SERVICE BULLETIN

IMPORTANCE	NORMAL
AREA AFFECTED	LANDING GEAR
SA/B NUMBER	CH 015-05-2021
EFFECTIVE DATE	5 MAY 2021

Inspection of the radius block installation bolts to ascertain the position quantity of washers.

Figure 1: Correct Washer Location

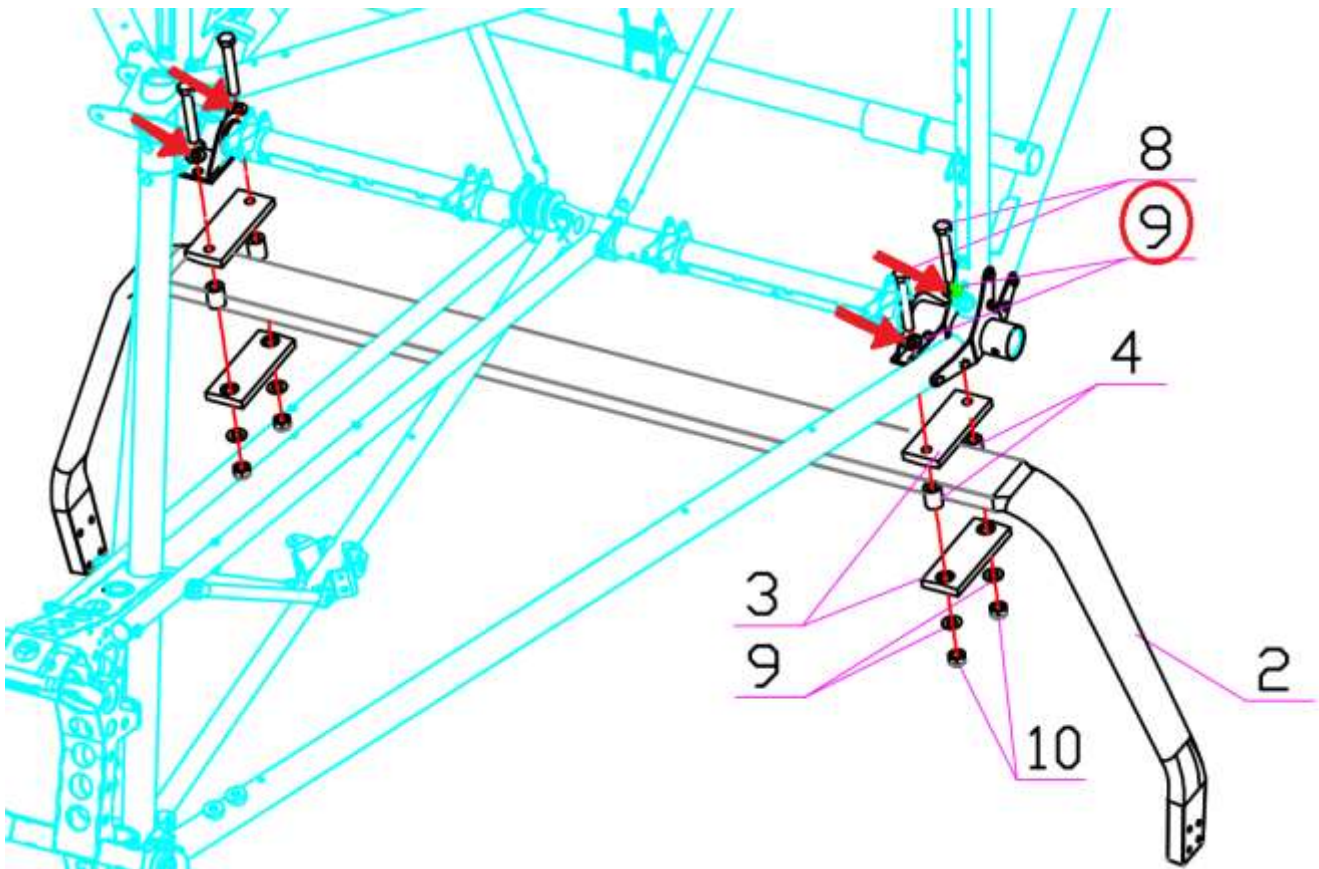
During a kit build, it was discovered that the locations shown in the manual for the washer installation were incorrect for one step of the assembly process. This could lead to incorrect loading of the washer and bolt.

1. All the relevant aircraft radius block assemblies must be inspected at the next maintenance or inspection interval. This can be done before then if the pilot desires. With reference to Figure 1, the washers should be located with one between each bolthead and the bracket, and then one between the lower radius block and the Nyloc nut. This applies to all 4 of the bolts, i.e. 8 washers in total. These are shown by the label '9' in the figure, and the ones that might be incorrectly installed/missing are shown with arrows. Look to see if there are washers installed above the upper radius block between it and the bracket above.

2. If the washers are all in place correctly, with no additional ones, no modification is needed. If there are extra, missing, or incorrectly installed washers, please contact the factory/distributor and tell them the findings, and request the BCUG-083 upgrade kit which will provide the parts and instructions on how to correct the installation.
